The property located at 611 West 98th Street shall comprise the boundaries for this USD.

The property will have a newly built Bank of America located within its boundaries. This building will utilize wall signage, freestanding signage, and informational signage throughout the property. Details of all signage on the property are listed within this USD. Please see attached prints for exact locations and specific details for each sign:

APPROVED
Zoning Review Only
04/20/2021 NMJ

CASE #PL2021-72

PRIMARY ELEVATION (EAST)

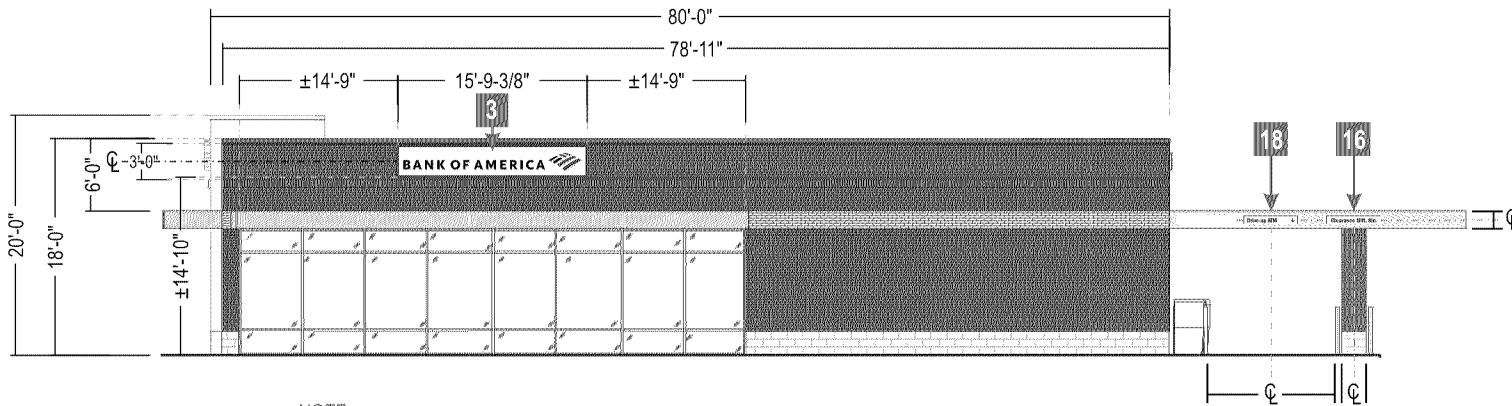
NOTE:
SIGN AREA CALCULATIONS
18'-0" HEIGHT x 53'-0" WIDTH = 954 SQFT
~~1100 SQ FT - 10% ALLOWED BY CODE = 1100 MAXIMUM SQ FT~~
8% allowed = 76 square feet

SECONDARY ELEVATION (NORTH)

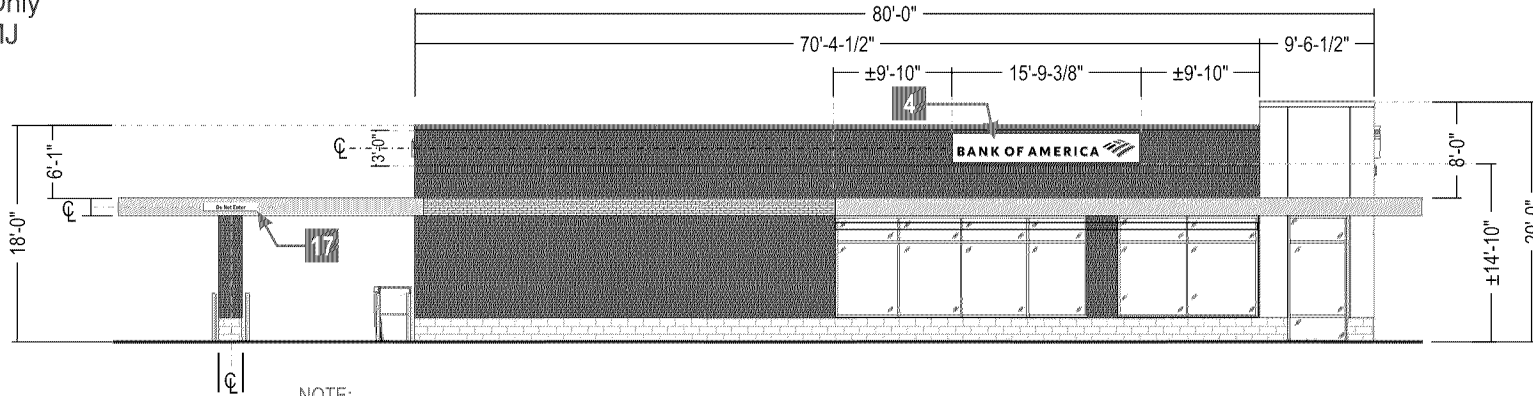
NOTE:
SIGN AREA CALCULATIONS
18'-0" HEIGHT x 80'-0" WIDTH = 1440 SQ FT FACIA
~~1100 SQ FT - 10% ALLOWED BY CODE = 1100 MAXIMUM SQ FT~~
4% allowed = 58 square feet

SECONDARY ELEVATION (SOUTH) 4% allowed= 58 square feet

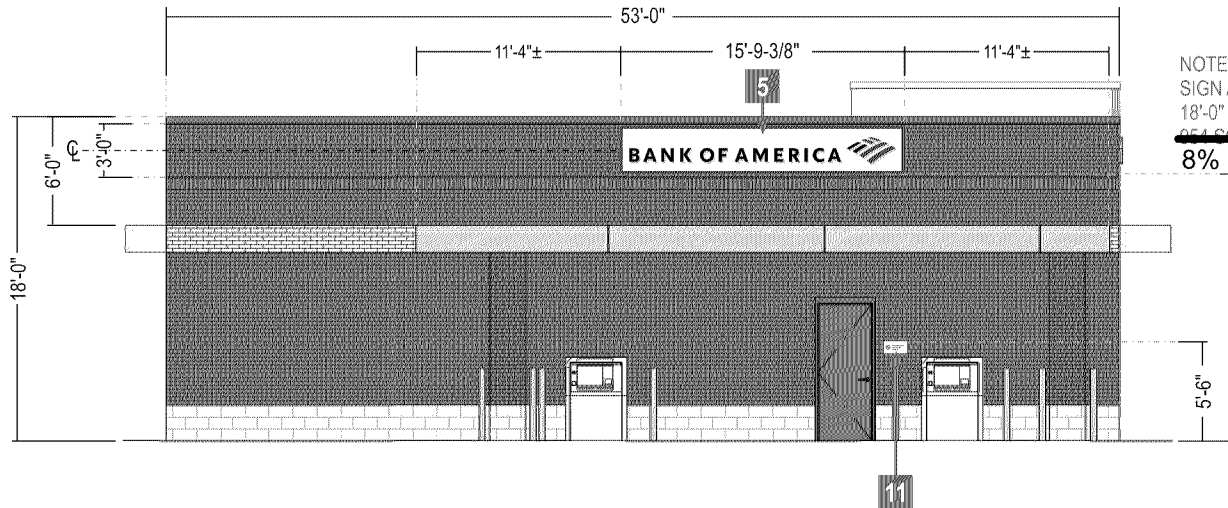
NOTE:
SIGN AREA CALCULATIONS
18'-0" HEIGHT x 80'-0" WIDTH = 1440 SQ FT FACIA
~~1440 SQ FT x 40% ALLOWED BY CODE = 576 MAXIMUM SQ FT~~
